Groundwater Application Review Summary Form

Application # G- 18524

TO: Water Rights Section Date 7/31/2017
 FROM: Groundwater Section Jen Woody
 Reviewer's Name
 SUBJECT: Application G- 18524 Supersedes review of n/a
 Date of Review(s)

A. GENERAL INFORMATION: Applicant's Name: Sarbanand Enterprises, LLC County: Yamhill

Figure 2. Well Location Map

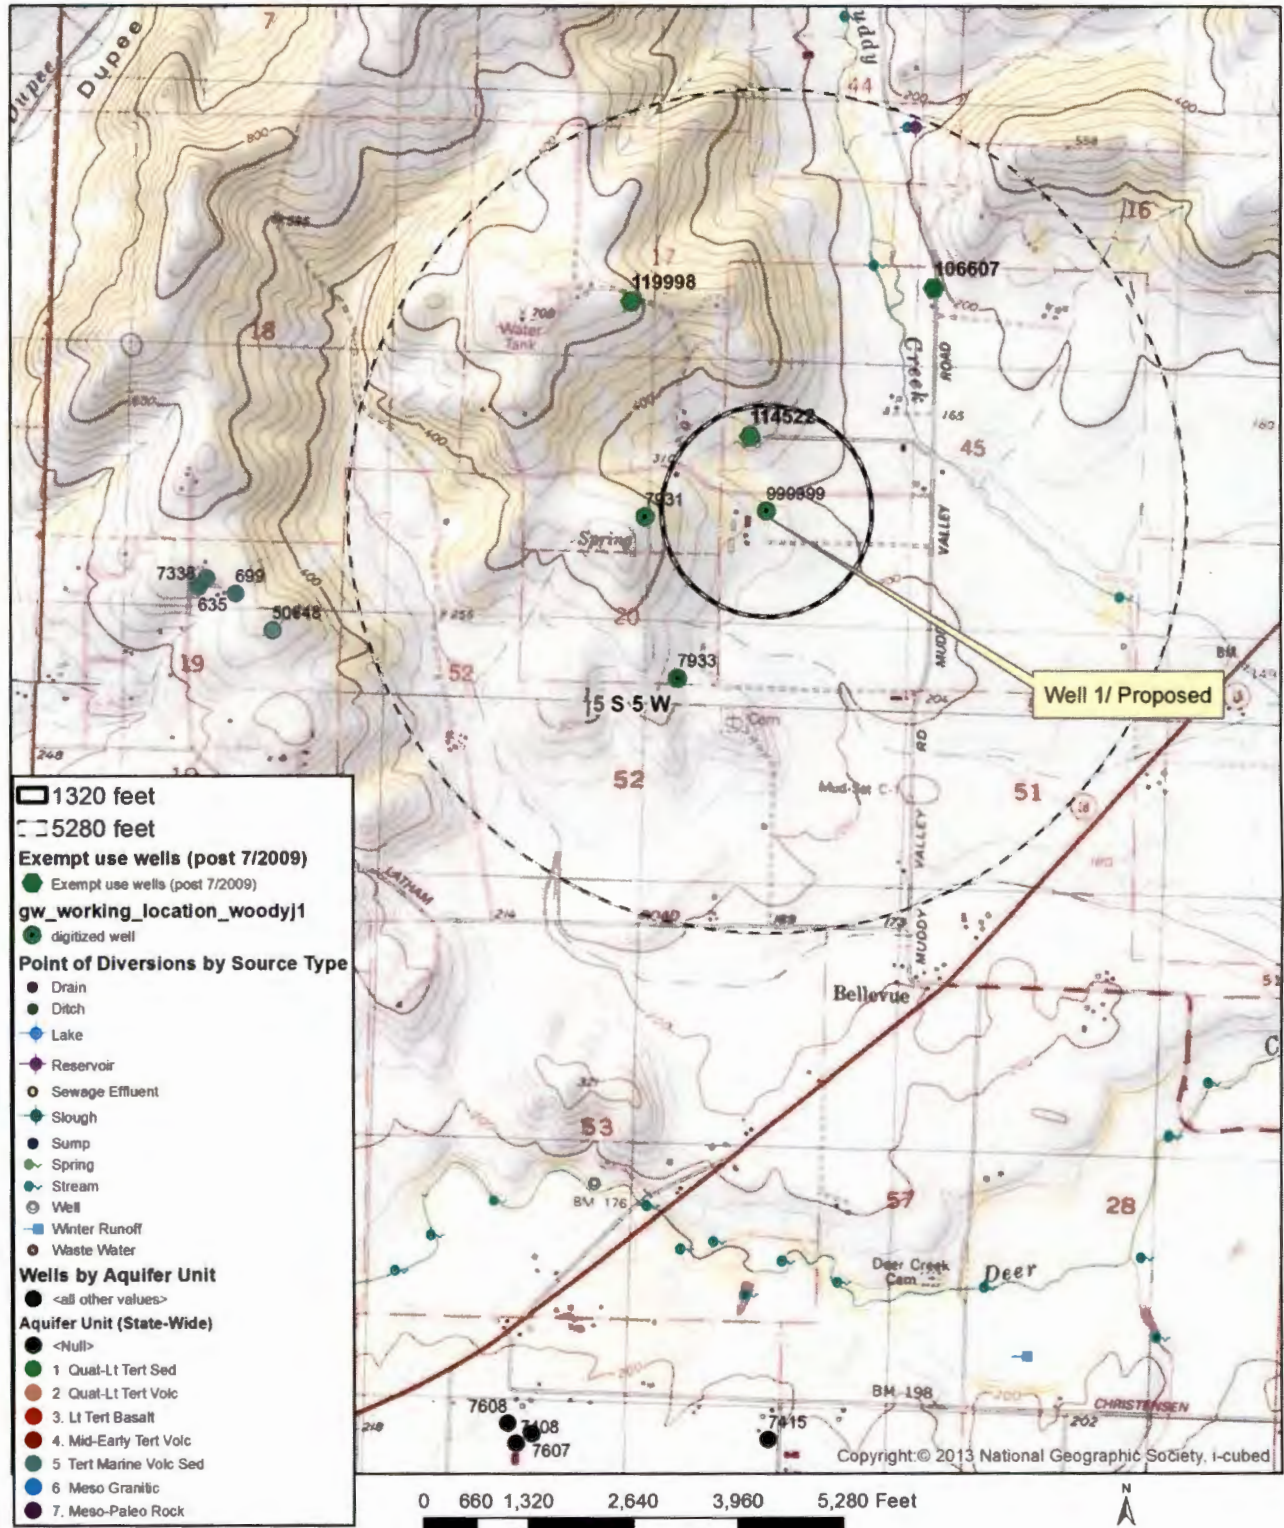
Well-to-well interference is unpredictable in fractured rock aquifers because fractures are not continuous or consistently connected. There are no nearby, long-term static water level data available in the subject aquifer (see Figure 2). Therefore, the groundwater resource cannot be determined to be over-appropriated. The proximity to neighboring wells raises the potential for interference with senior groundwater users (see Figure 3), but pumping drawdown effects in a low-yield, fractured rock aquifer are not expected to be widespread. Annual water level and water use monitoring and reporting conditions are recommended to address the potential impact to senior users.
